Vogtle Electric Generating Plant, Units 1 & 2
Response to Request for Additional Information Related to
Proposed Inservice Inspection Alternative VEGP-ISI-ALT-04-04 Version 2.0

SNC Response to Request for Additional Information (RAI)

**SNC Response to Item 2.c.i During the Continuation of the NRC Audit of the PROMISE
Version 1.0 Software on July 27, 2020**

Response to Open Audit Item 2.c.i.A (2 of 9)

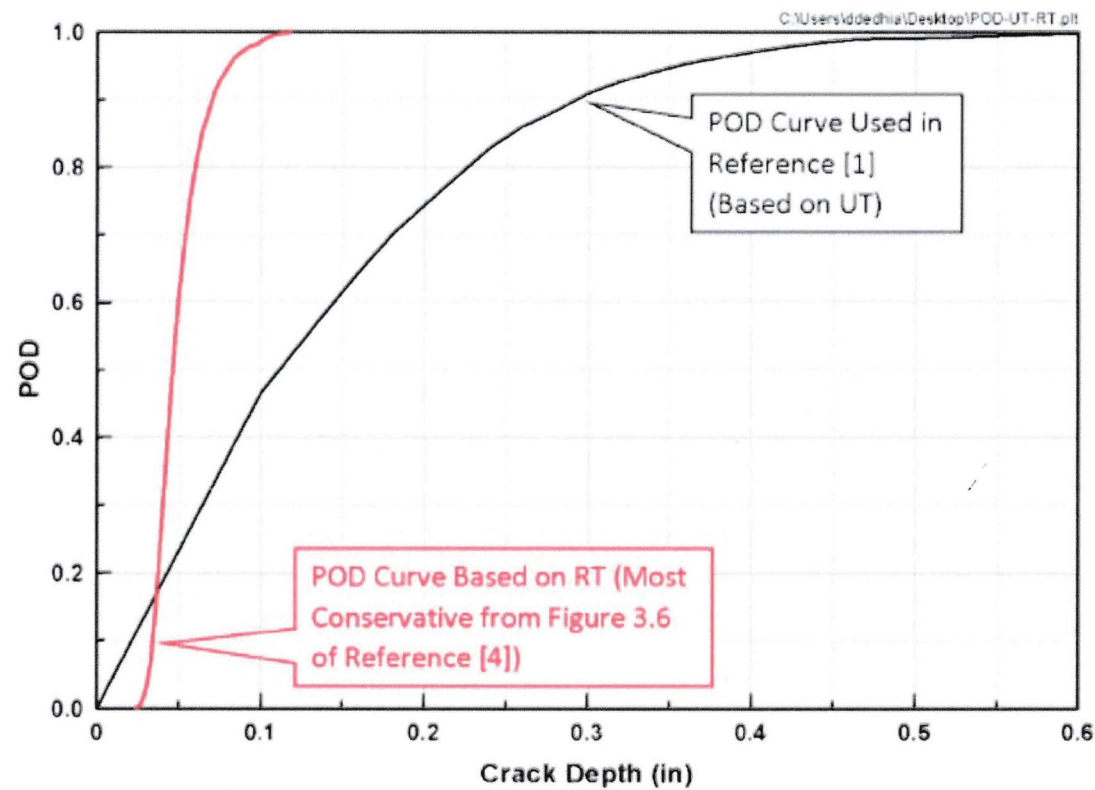
- A. Provide the rationale for the use of the same POD curve for both ISI and PSI.
- B. Provide the results of a PROMISE run using a limiting case with an assumption of 50% ISI coverage.

Regarding the Assumption of 100% Coverage for PSI:

- In Section 8.2.4.1.1 of the EPRI report, PSI refers to the collective initial ASME Code, Section III and Section XI examinations
- ASME Code Section III requires 100% coverage for RT exams
- ASME Code, Section III PSI examinations involving radiographic testing (RT) were performed and found acceptable for the affected welds of the VEGP Units 1 and 2 MS and FW nozzles
 - The acceptability of the ASME Code, Section III RT examinations indicates that 100% coverage was achieved during these examinations
- In addition, Section XI PSI (UT) exams were performed, some with limited coverage
- Collectively, both examinations covered 100% of the weld
